# Service Bulletin

**SUBJECT:** Service Update for Inventory and Customer Vehicles  
Auto-Leveling Rear Suspension Inoperative  
Expires with Base Warranty

**MODELS:** 2015 Chevrolet Suburban, Tahoe  
2015 GMC Yukon, Yukon XL  
2WD Vehicles Equipped with Auto Leveling Rear Suspension  
(RPO Z85 and AVF)

Subject: 15303 – Service Update Bulletin  
Auto-Leveling Rear Suspension Inoperative

### **Air Sack Damage**

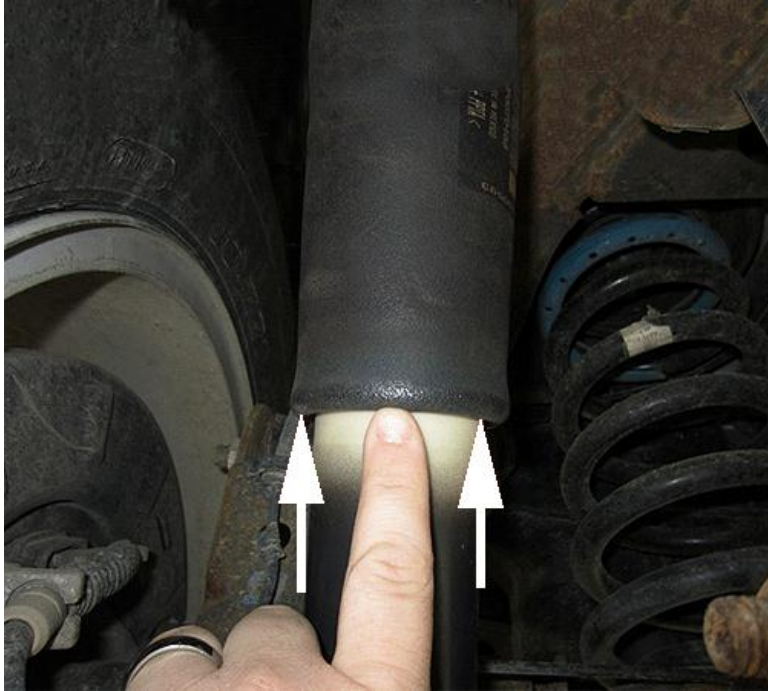
- Arrows point to trapped air sack between the shock body and the dirt shield. If this condition exists, the shock must be replaced. Inspect for rolling, folding, or any kinks in the rubber tube. Any shock with these conditions must be replaced.

### Check System Pressure

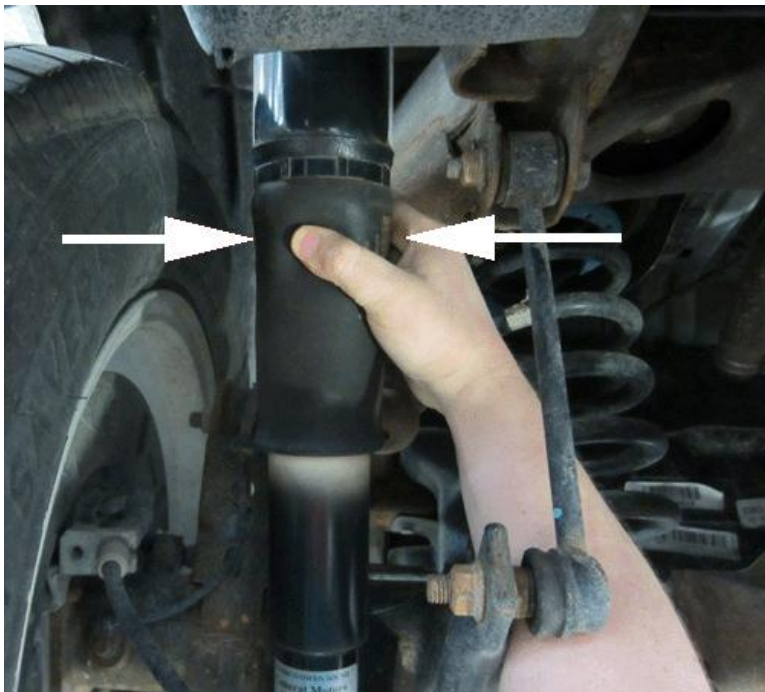
- Check shock absorbers for system pressure. Shock “A” has no pressure, and displays a tapered “waist” just above the bottom roll of the boot. Shock “B” has the correct pressure with a nearly uniform width top to bottom.
